IEEE 802.3cg
10BASE-T1S jabber problem
August 15th, 2018

Proposed solution

Figure 147-4—PCS Transmit state diagram (1 of 2)

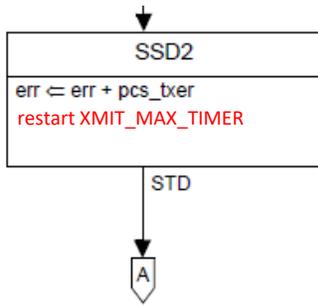
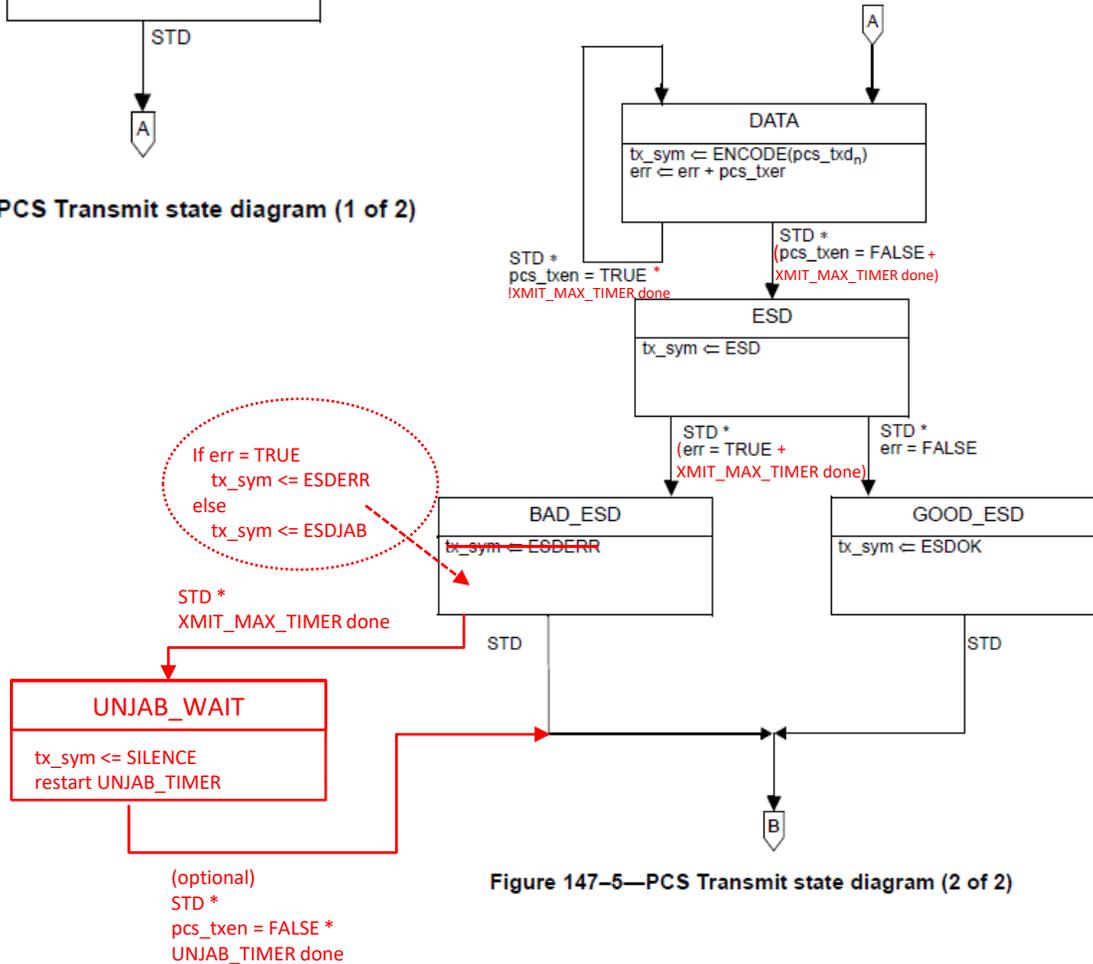
- Add XMIT_MAX_TIMER (2 ms ± 100 μs) to exit DATA state and notify the error to the receiving nodes
- Stay in UNJAB_WAIT state for 16 ms ± 100 μs (or forever) to allow other PHYs to transmit
- NOTE: local CRS is high (transmitting variable is still TRUE) during unjab time to prevent the MAC from transmitting as well
- Adapted from Fig. 10-3

- Adopt changes to Figures 147-4/1 and 147-5 as in slide #3
- 147.3.2.6 Timers
 - XMIT_MAX_TIMER
 - Defines the maximum time the PCS Transmit state machine can stay in DATA state.
The XMIT_MAX_TIMER shall be implemented in such a way that, upon expiration, an even number of nibbles has been sent to prevent the MAC from counting false alignment errors.
Duration: $2\text{ms} \pm 100 \mu\text{s}$
 - UNJAB_TIMER
 - Optionally times the minimum duration the PHY suppresses any transmission before reverting to normal operations.
Duration: $16\text{ms} \pm 100 \mu\text{s}$
